APPEAL SUMMARY

Appeal ID: 24649	Project Address: 915 NE Schuyler St
Hearing Date: 2/24/21	Appellant Name: Hali Knight
Case No.: B-012	Appellant Phone: 9713523935
Appeal Type: Building	Plans Examiner/Inspector: Steven Mortensen
Project Type: commercial	Stories: 9 Occupancy: R-2 Construction Type: 1-A
Building/Business Name:	Fire Sprinklers: Yes - Throughout
Appeal Involves: Alteration of an existing structure	LUR or Permit Application No.: 20-185703-CO
Plan Submitted Option: pdf [File 1] [File 2] [File 3] [File 4] [File 5]	Proposed use: Residential

APPEAL INFORMATION SHEET

Sheet Title:
FIRE & LIFE SAFETY PLANS

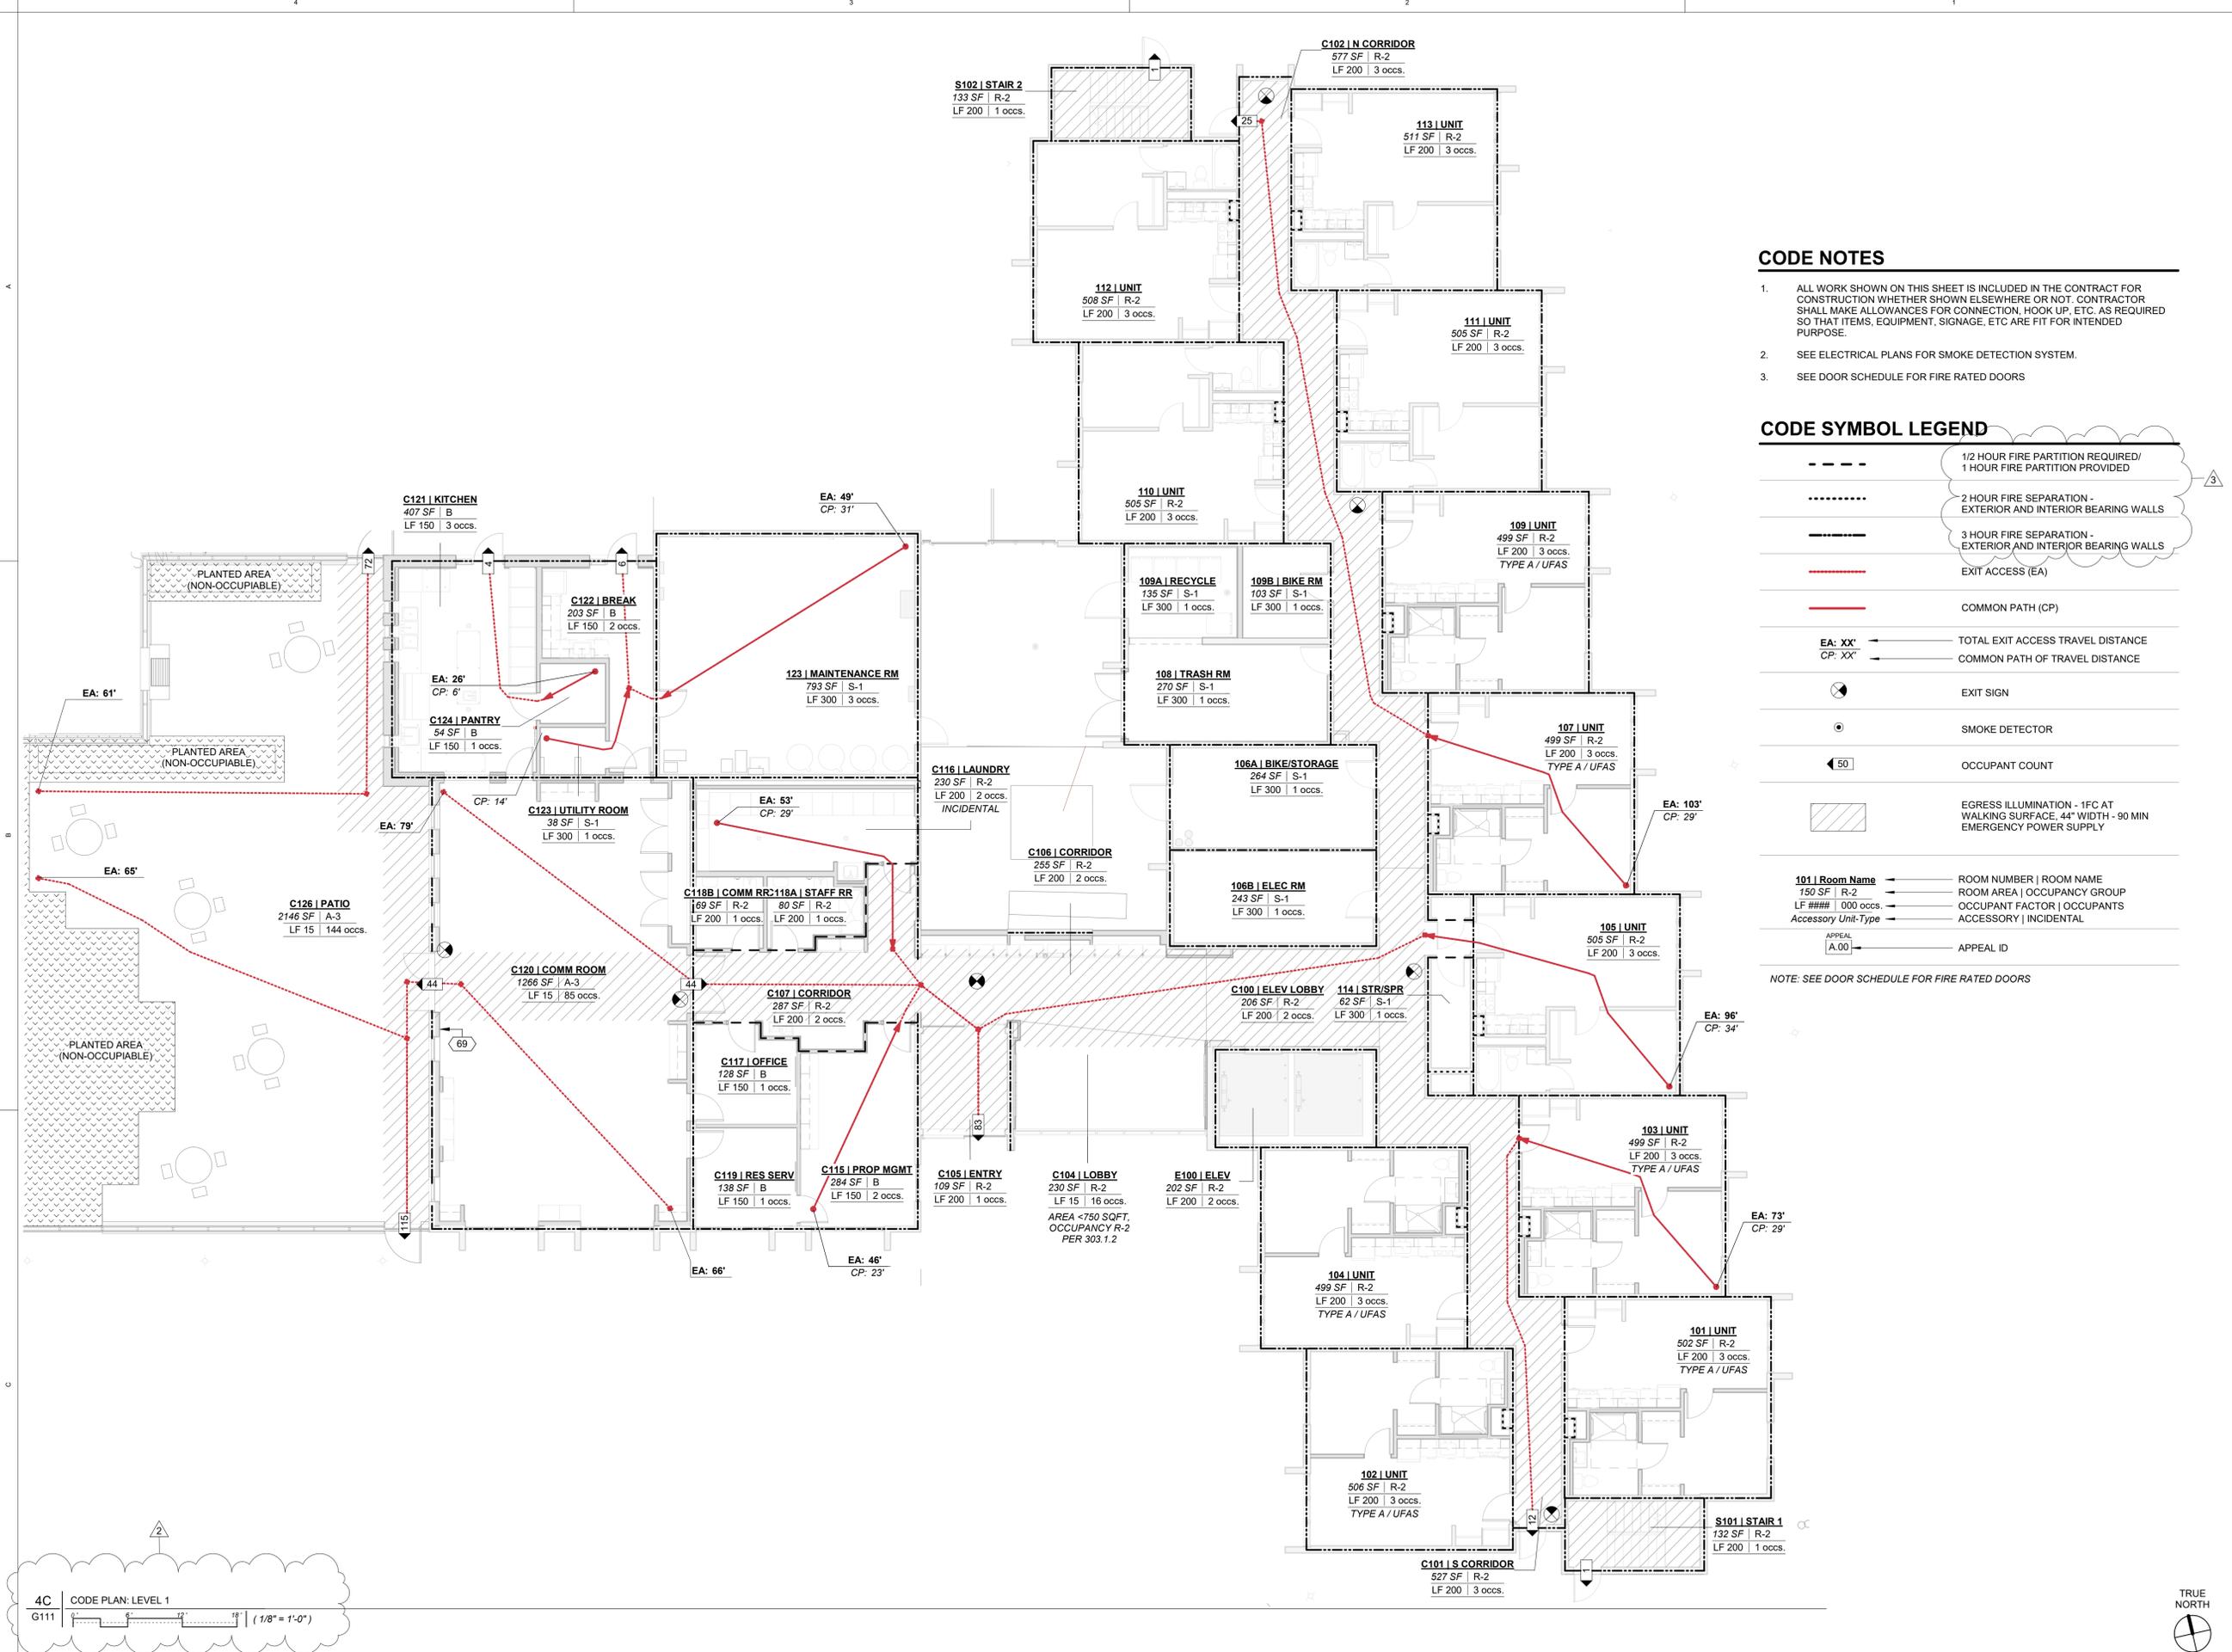
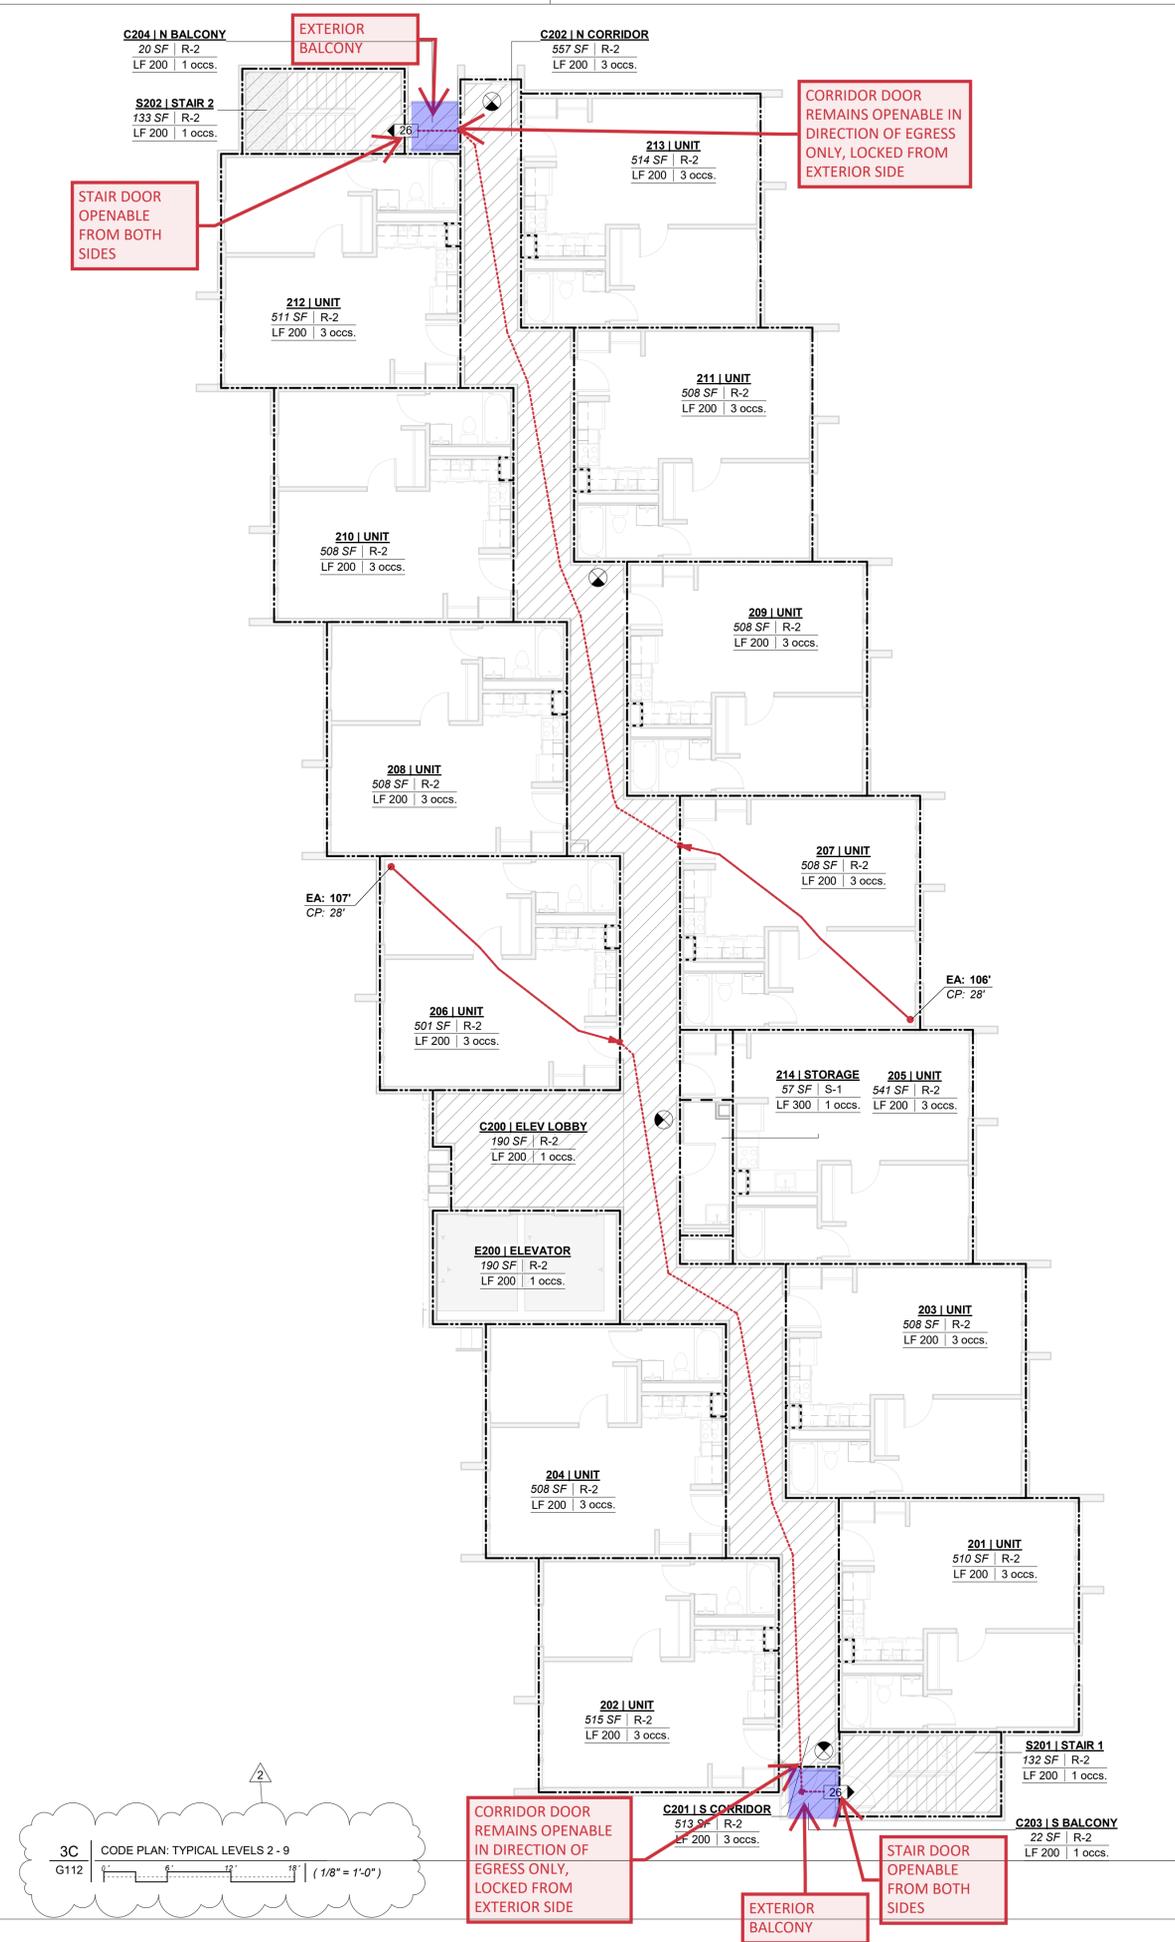
Code Section	1010.1.9.12 Stairway Doors
Requires	Interior stairway means of egress doors shall be openable from both sides without the use of a key or special knowledge or effort.
Code Modification or Alternate Requested	Exception to 1010.1.9.12 to allow for the exterior egress corridor doors on floors 2-9 to have exterior locking (non-egress side of door) for security to the building since these open onto exterior exit balconies. These egress corridor doors shall be openable from egress side without the use of a key or special knowledge or effort.
Proposed Design	<p>The Dahlke Manor is an existing 9 story apartment building built in 1971. The proposed scope of work is to reconfigure the ground level spaces to better serve the residents, build a small (<750 sqft addition), replace finishes in the residential units, and convert six of the existing dwelling units to accessible Type A units. Full NFPA 13 sprinkler system will be provided throughout building along with fire detection and alarm system. G006 and G007 Code Analysis sheets attached for reference.</p> <p>The existing egress for the residential tower includes two stairwells that are reached from corridor doors by an exterior balcony. The existing corridor doors are exterior doors and locked from the exterior side to prevent entry from the exterior balconies, a necessary security measure for the building. The stairwell doors will remain operable from both directions, except the ground floor egress door which will remain locked from the exterior non-egress side. Since the doors will receive new hardware as a part of the scope of work, the corridor door does not meet 1010.1.9.12 and an exception is requested. A KnoxBox will be provided on the ground floor to provide building access to Portland Fire & Rescue, including access to the exterior corridor doors.</p>

Reason for alternative	The corridor door is not part of the interior stairway and is separated by an exterior balcony. The existing corridor doors need to be locked from the exterior side to prevent entry from the exterior

balconies, which is a necessary security measure for the building. All inhabitants exiting the building will be able to freely, without special knowledge or effort, access the stairway and will have a protected path to the exterior of the building. The stairway is emergency egress only and is protected by 3-HR fire-rated construction. Residents exiting in the stairway do not need to re-enter the building to exit the stairway tower and there are no locked doors on their egress path out of the building. A KnoxBox will be provided for Portland Fire & Rescue to enter the building from these corridor doors. See markups on attached plans G111 and G112 and door schedule on A600.

- 1. Corridor exit access doors on floors 2-9 with locking hardware on non-egress side: Granted provided door is unlocked upon activation of Fire alarm and provided door hardware is verified at time of plan review.**

Fig 1: C-Channel Locations.

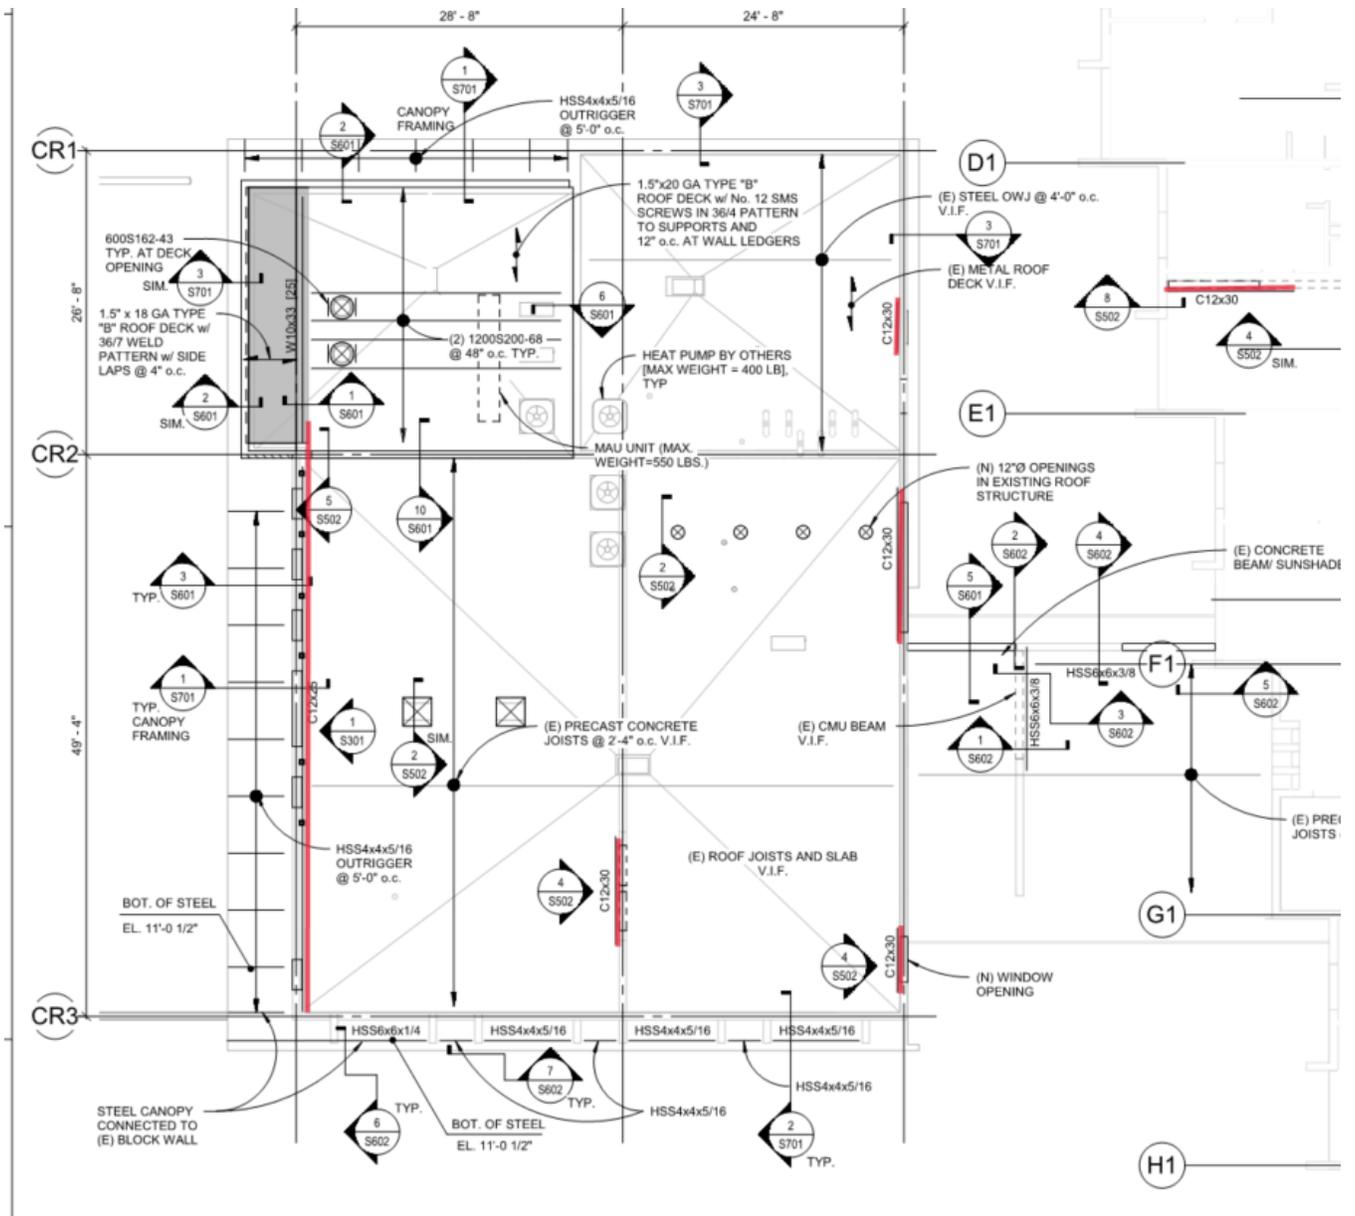
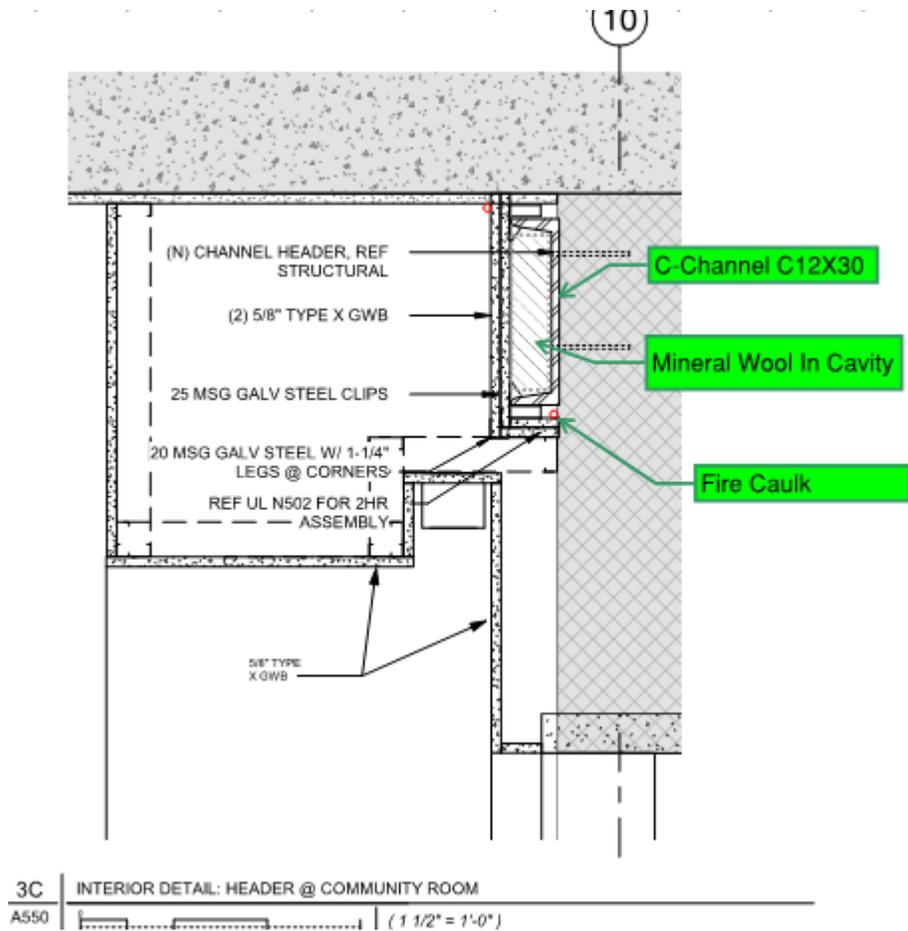
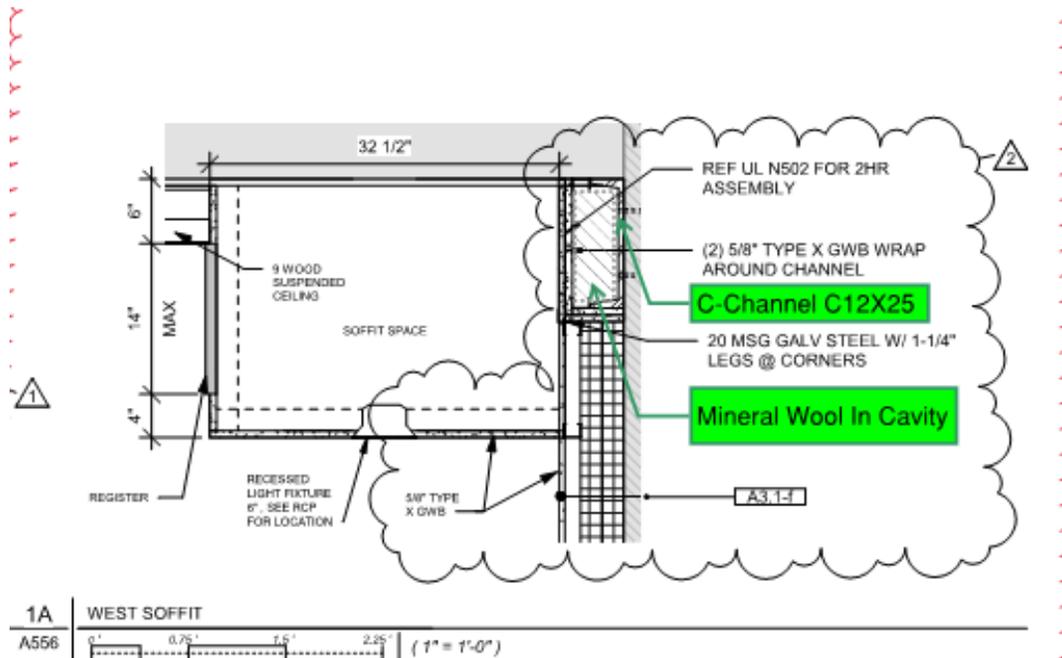
Code Modification or Alternate Requested This appeal demonstrates 3-hour protection of structural channels at the existing walls based on the attached engineering analysis.

The proposed C-Channel of C12x30 and C12x25 members located against the existing walls require 3-hour protection (see attached engineering judgment letter) For this study, only the C12x25 member will be examined in detail because it is the lightest member and therefore has the least inherent fire resistance. This member is considered as a primary structure. Per 2019 OSSC table 601, primary structural members are required to be minimum 3 hr. fire rated for the construction Type. It is assumed that the beam will be exposed to fire on the left side and the assembly will require continuous protection from three sides.

The C-Channel will comply with the required 3-hr fire resistance requirement if protected by 2 layers of 5/8" Type X gypsum wallboard and mineral wool filling gaps. The proposed C-Channel

has greater inherent fire-resistance with a larger W/D ratio; therefore, the thicker layers of protection will provide a greater fire resistance than the tested member. Additionally, the backside boards a heat sink of concrete or CMU wall which will draw away heat from the member further extending the protection duration.

- 2. Alternate 3 hour fire rated structural channel assembly with engineering analysis: Hold for additional information. See note below regarding the process for submitting additional information.**
